**Walton County  
The Grove**

**Change Proposal #9  
Building J VE Permit Changes  
Rev I**

**Change Proposal #9 – Building J (Maintenance) VE Permit Revisions Rev 1**

**A2.01J**

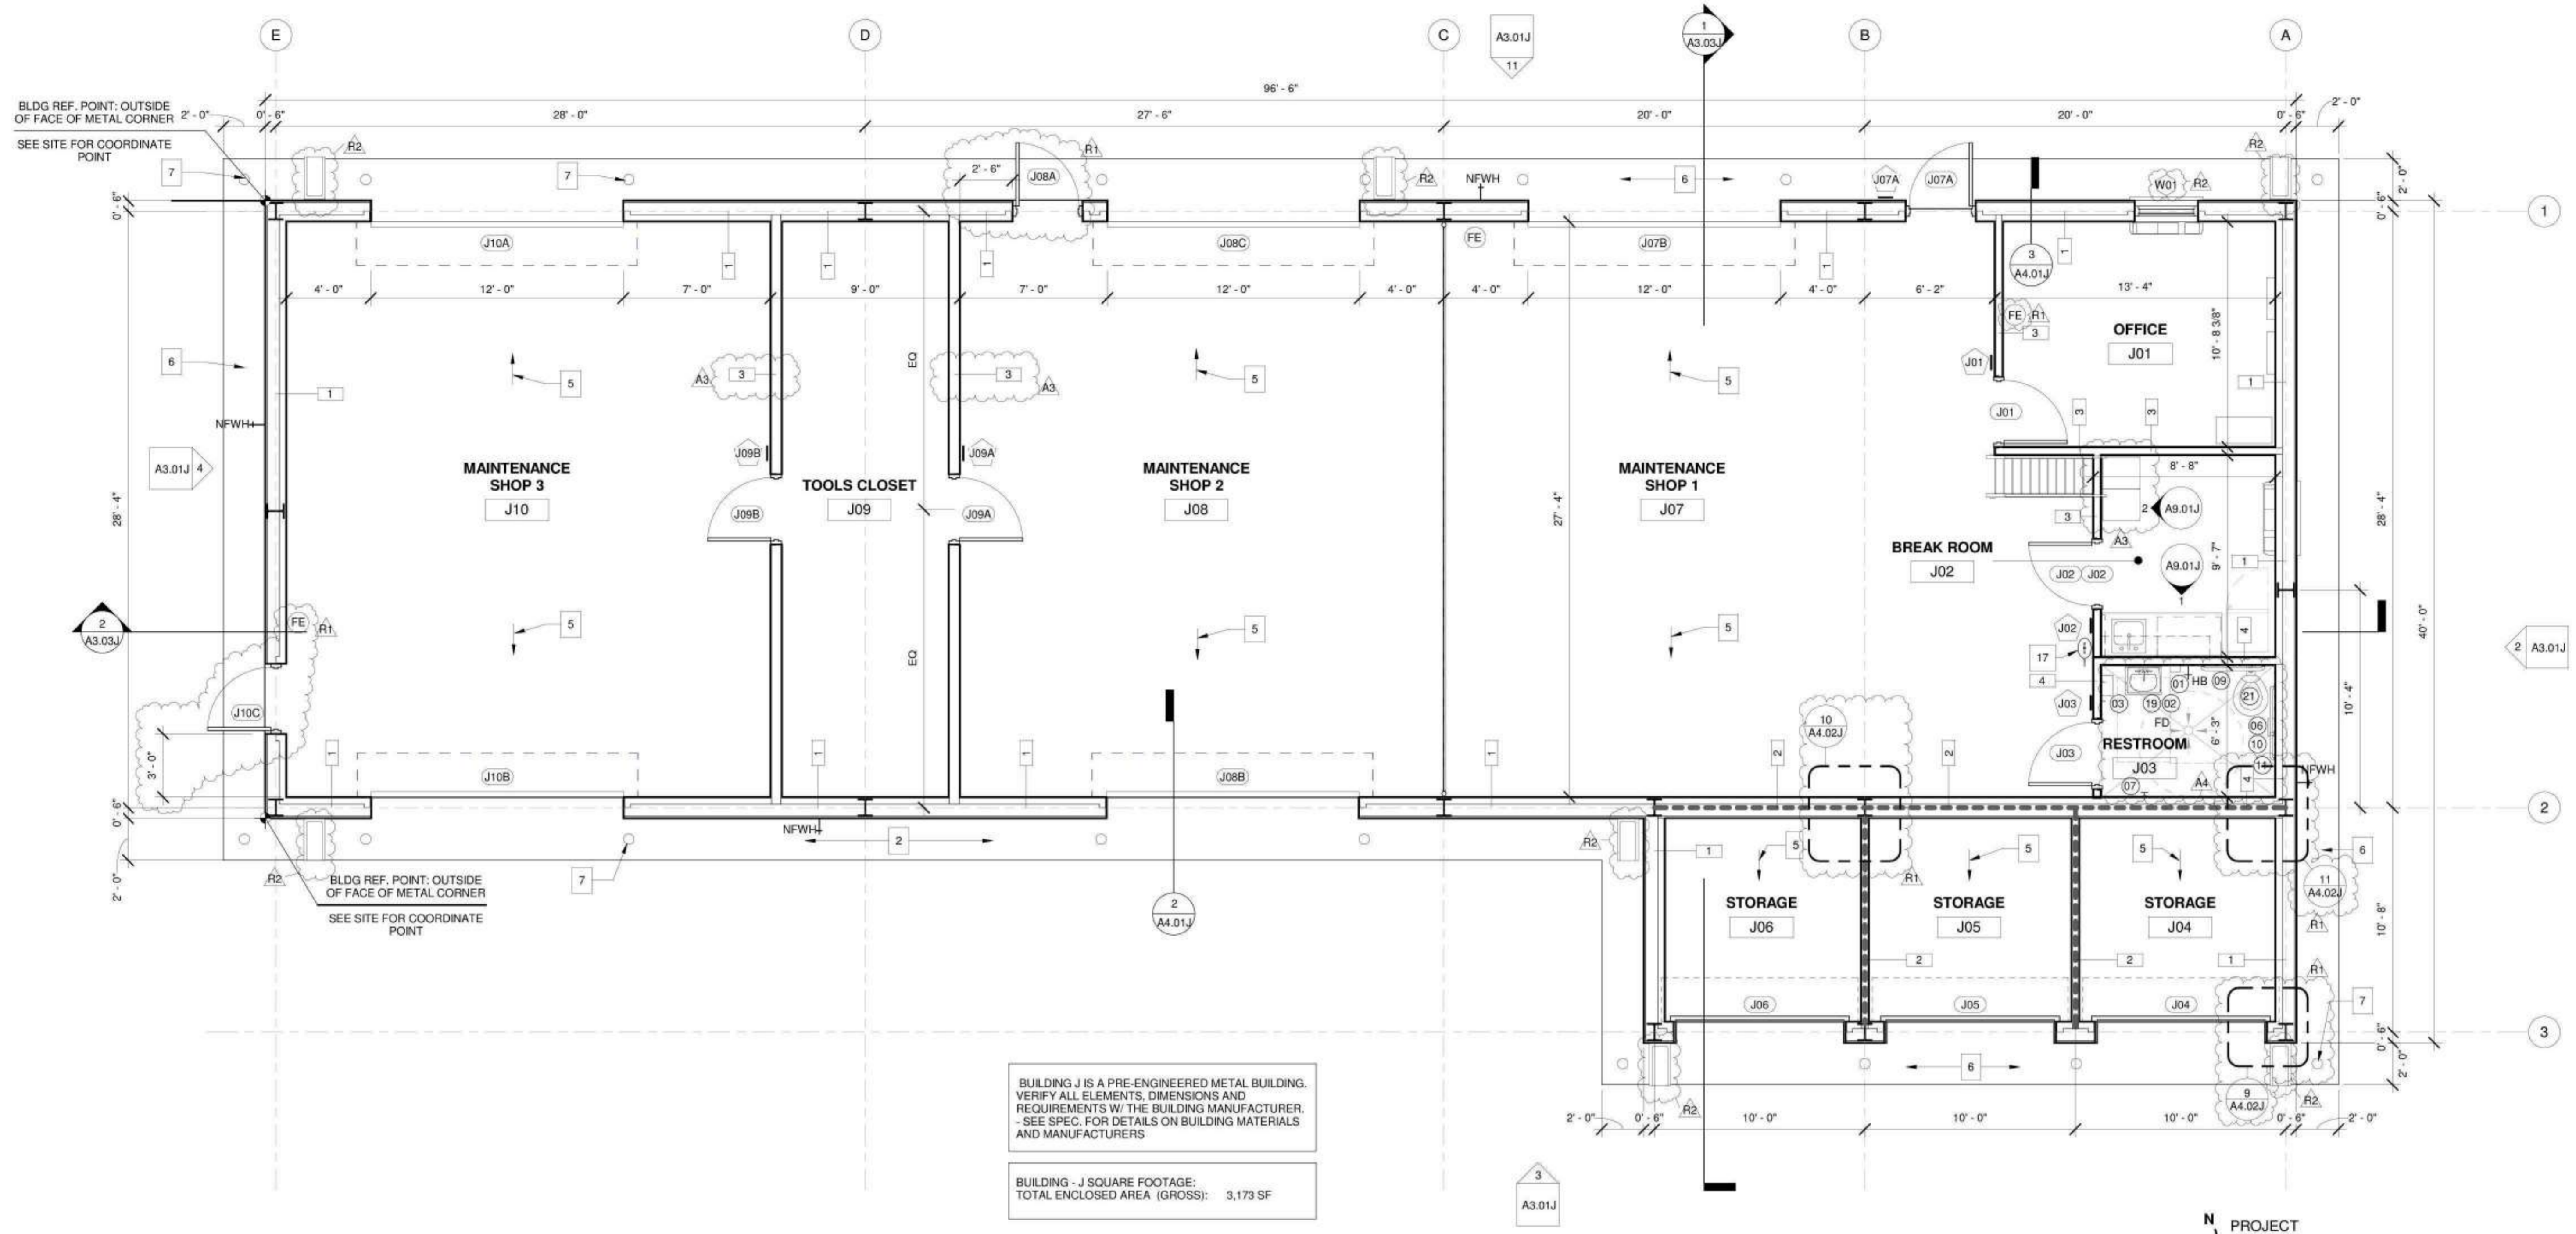
The below change proposal is for the cost associated with the design changes incorporated in the VE permit set for building J. These changes include additional HM openings, eyewash station, water heater, and storefront frame added. Please see below for further supporting documentation.

- Additional Doors, Frames, & Hardware:
  - Building J – HM 14GA Galvanized Frame & Door w/ Finish Hardware
    - J08A
    - J10C
- 10% Mark-up

WC To pay for one additional HM opening. WC to clarify which opening is to remain.

**UPDATE:** Per conversations with Jeff Prine of APM on 11.22.24, only one HM Opening will be added to the Maintenance building in lieu of what is shown on the permitted VE set. The pricing update is reflected below.

**P-0.1J**

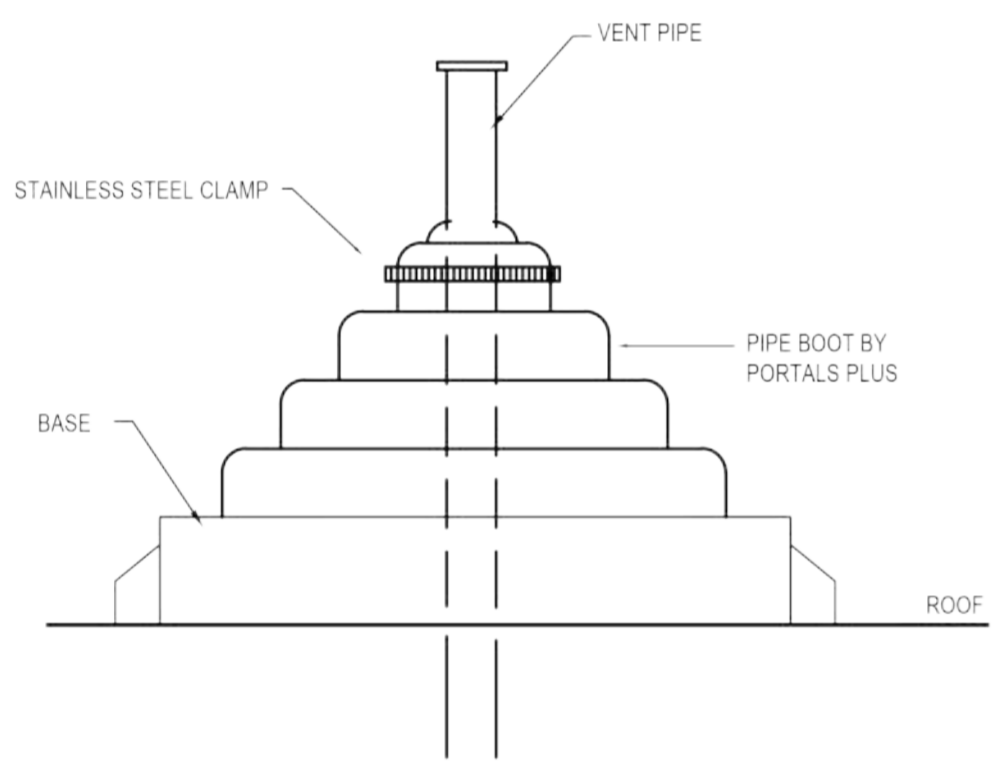
Project: The Grove – Building J  
Change Order Request: Conformed Set Changes – Building J  
Scope Of Work: Addition of Eye Wash and WH-3

qty	Materials		
1	Eye Wash	Guardian G1814P	397.00
1	WH-3	Chronomite R-75L/208	540.00
1	Piping	Copper/PVC Fittings (1 lot)	225.00
1	*Mixing Valve	Guardian G6020 - ASSE 1071 Thermostatic mixing Valve	884.00
<b>8 hrs</b>	<b>Labor</b>	2 men, 4hrs @ \$125	1000.00
	Subtotal		3046.00
	OH&P	15%	457.00
	<b>TOTAL</b>		<b>3503.00</b>

\*The ASSE 1071 Mixing Valve offered above is required by code for emergency eyewashes. Unlike the standard ASSE 1070 mixing valves used for lavatories, the 1071 for tepid water emergency plumbing fixtures fails to cold to prevent scalding.

**E2.1J**

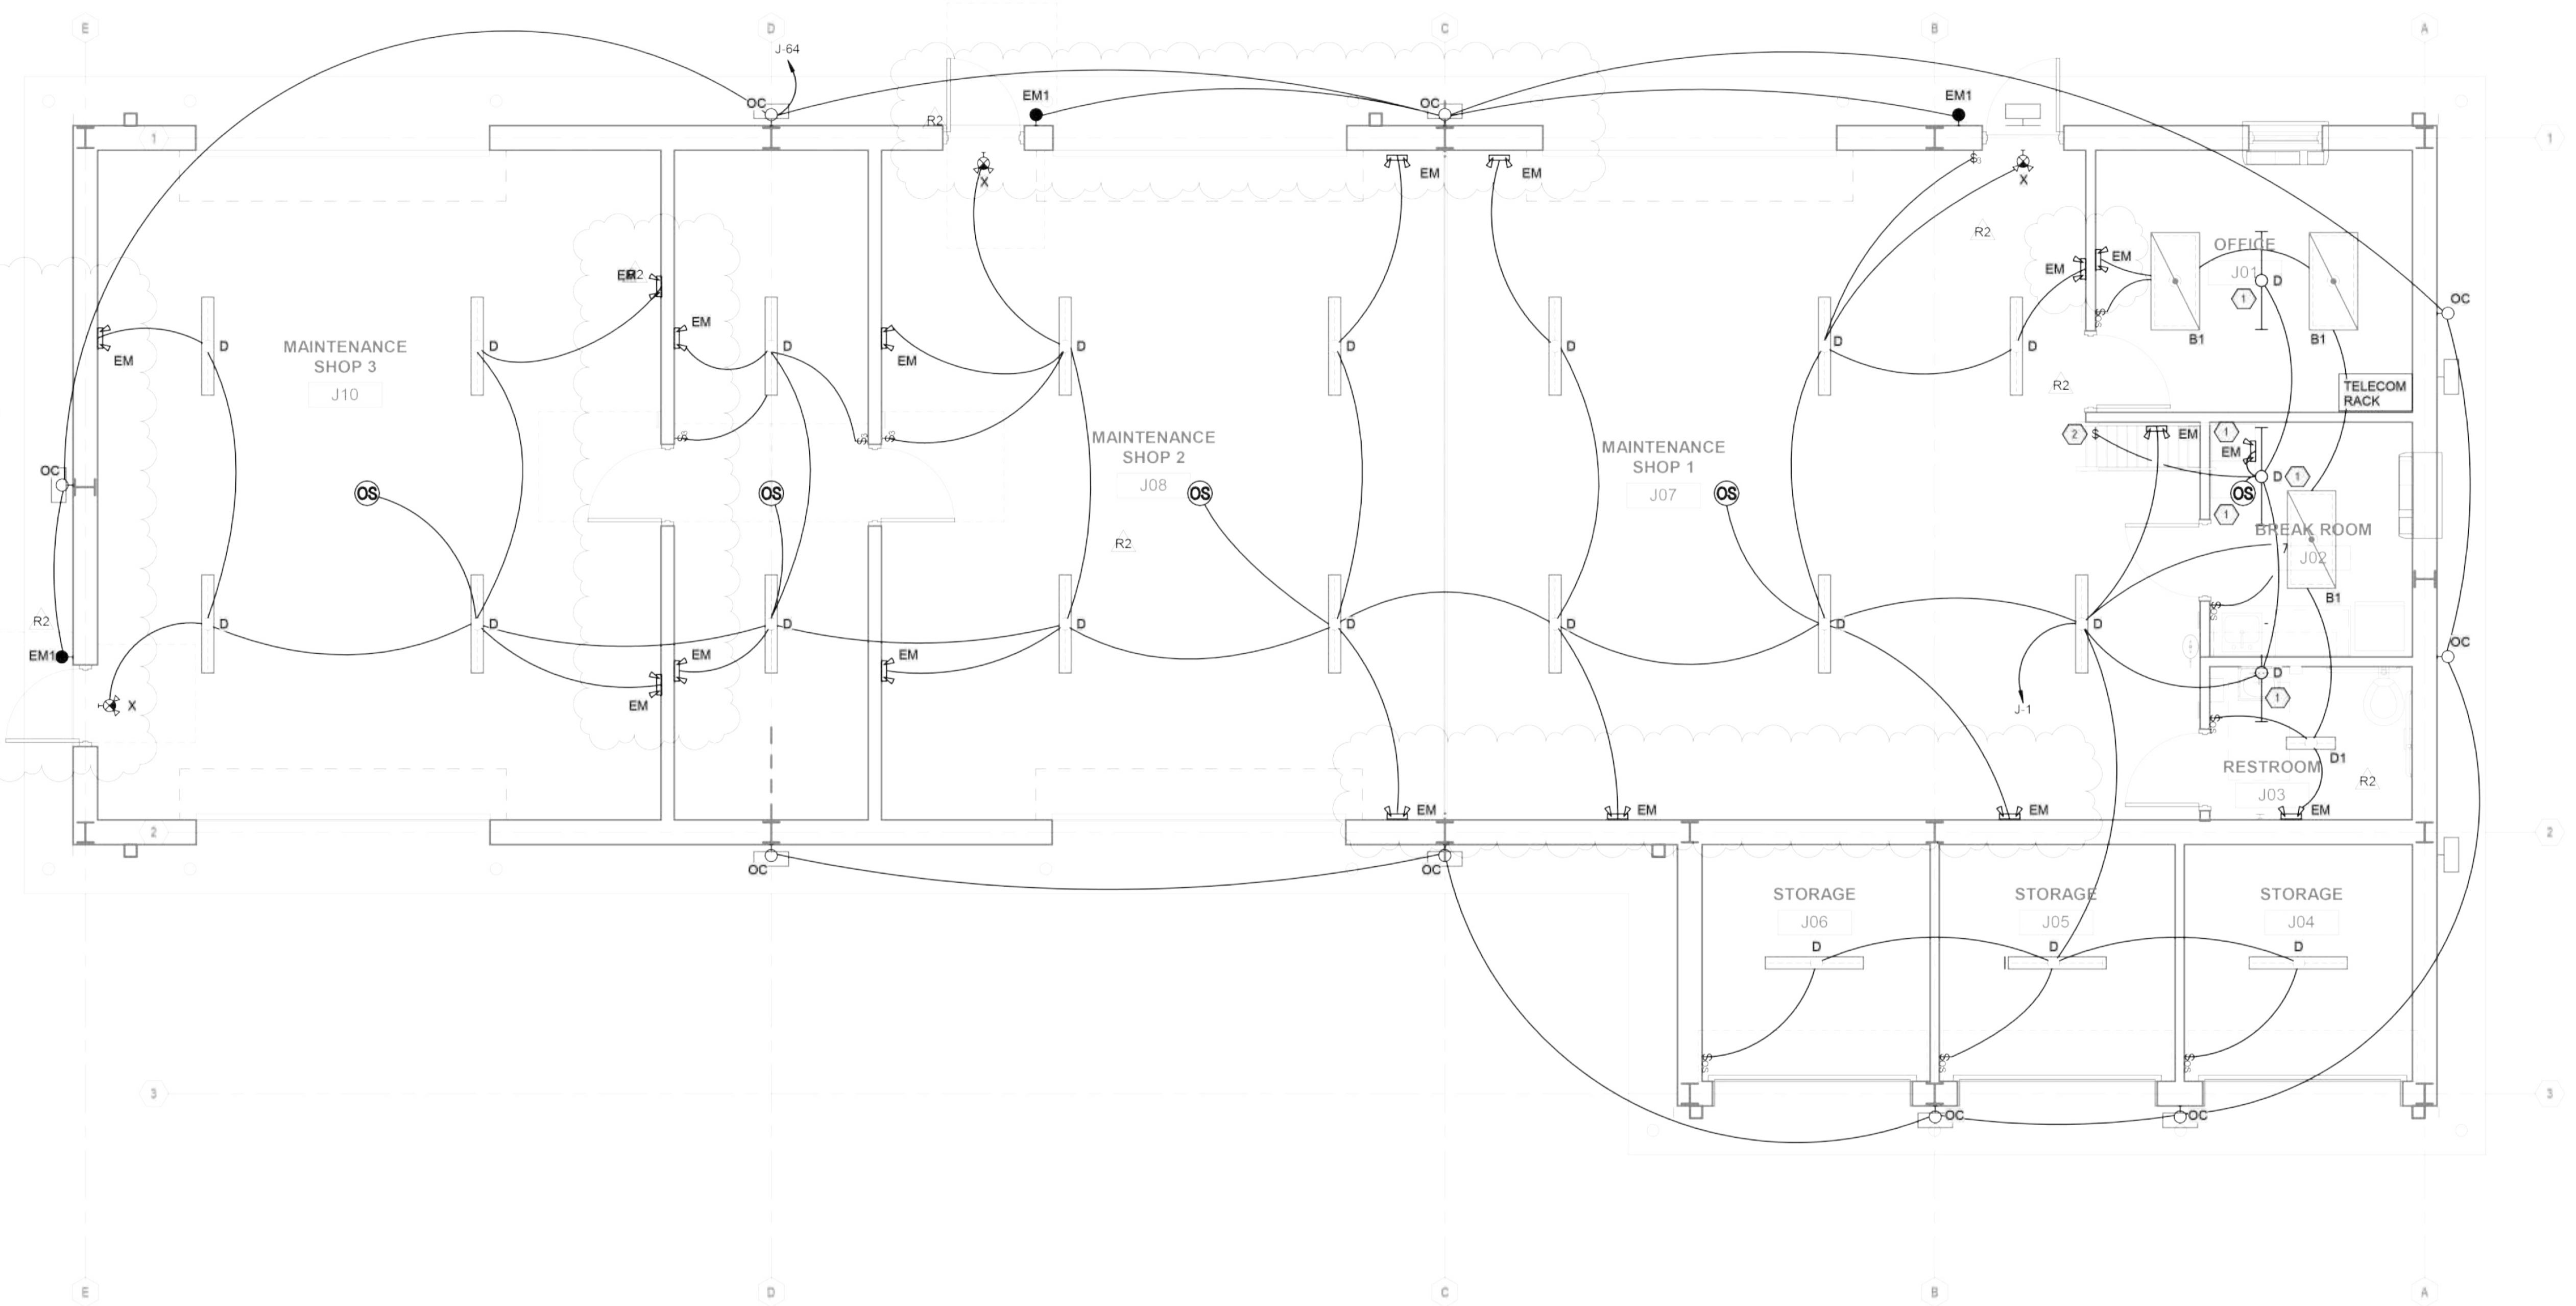
DATE	ACTIVITY	DESCRIPTION	QTY	RATE	AMOUNT
	Change Order	This change order pertains to the electrical changes made to Building J. Drawings dated 09.19.2024.	1	0.00	0.00
	Material	Misc. Material: ~ Conduit ~ Couplings ~ Connectors ~ Wire #12 ~ Boxes ~ Switch ~ Mud Rings ~ Straps ~ Screws ~ Wire Nuts	1	583.09	583.09
	Material	Lighting Fixtures: ~ EM (15) ~ EM1 (2) ~ Exit Signs (2) ~ D (3) ~ OS (1)	1	2,150.37	2,150.37
	Labor	Below is a cost breakout for Labor associated with the scope of work being performed. 3 electricians x 1 week each	150	57.46	8,619.00
	Tax	Tax Rate @ 6%	0.06	2,733.46	164.01
	Overhead/Profit	Overhead/Profit @ 10%	0.10	11,352.46	1,135.25
